DIST	COUNTY	ROUTE	KILOMETER POST TOTAL PROJECT	SHEET No	TOTAL SHEETS
04	SF	80	13.2/13.9	133R1	1204

CONTRACT CHANGE ORDER NO. 11
SHEET 11 OF 13

DETAILS
SAS SUPERSTRUCTURE ROADWAY WESTBOUND
CONDUIT LOCATIONS
SCALE AS NOTED

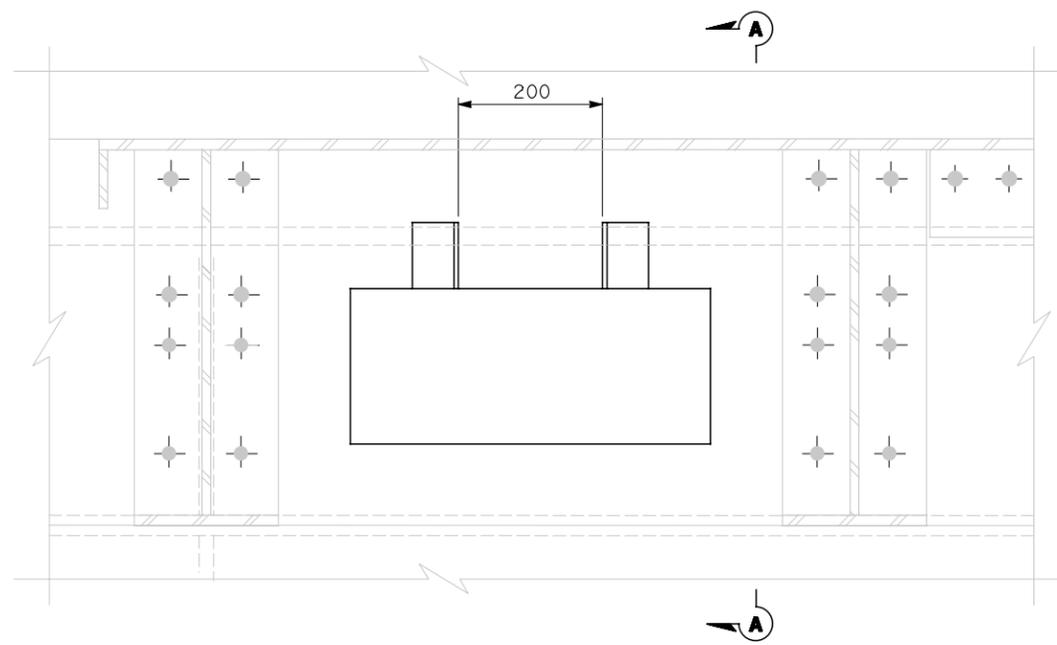
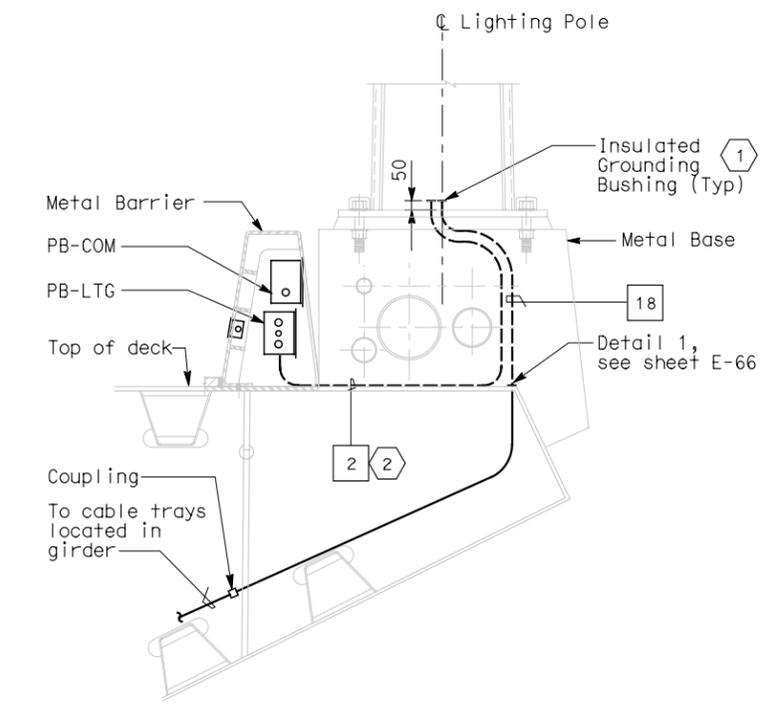
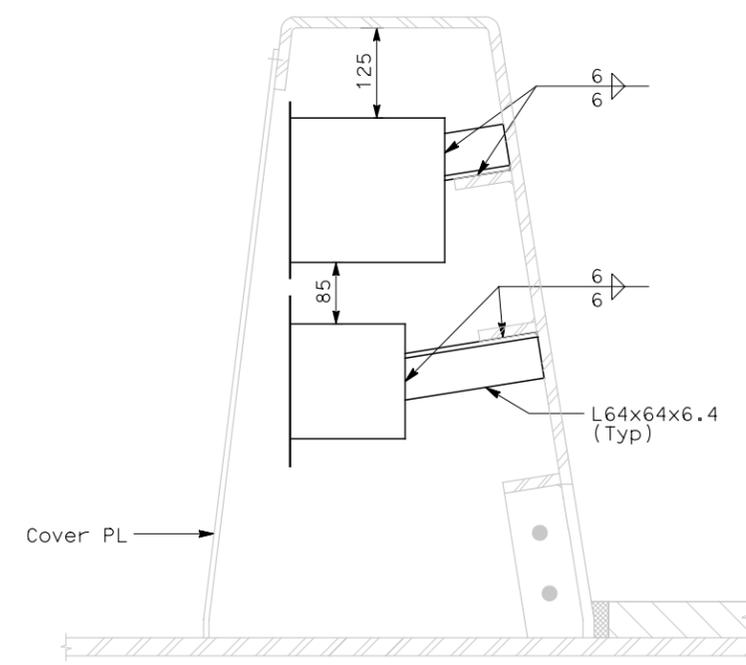
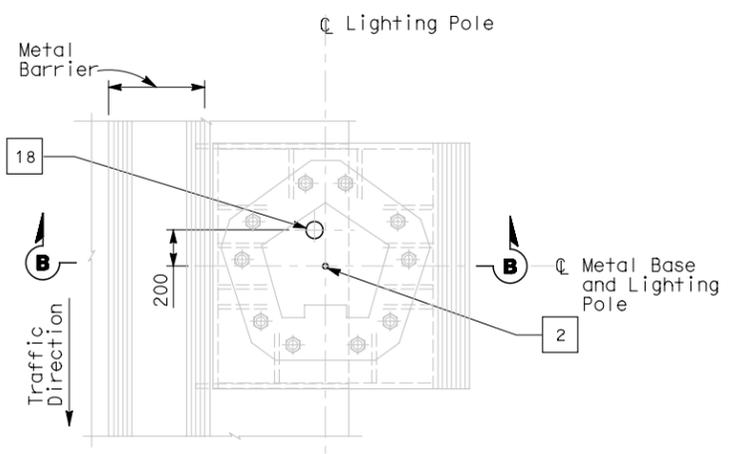
MARK	DATE	DESCRIPTIONS	REV	CK	CCO NO.
1	10/16/06	Revised sheet notes.	LR	MG	11

- 1 Bond grounding bushing to ground lug of lighting pole or overhead sign post with #6 bare copper wire.
- 2 Conduit shall clear all piping and pipe sleeves. Route conduit on top of deck plate, outside of girder box.
- 3 See Utility Detail No. 1 (Sheet No. 965 of 1204) for conduit penetration through girder plate and lighting pole metal base. The Contractor shall install sealant between the sleeve and conduit to prevent water or moisture from passing inside the sleeve.
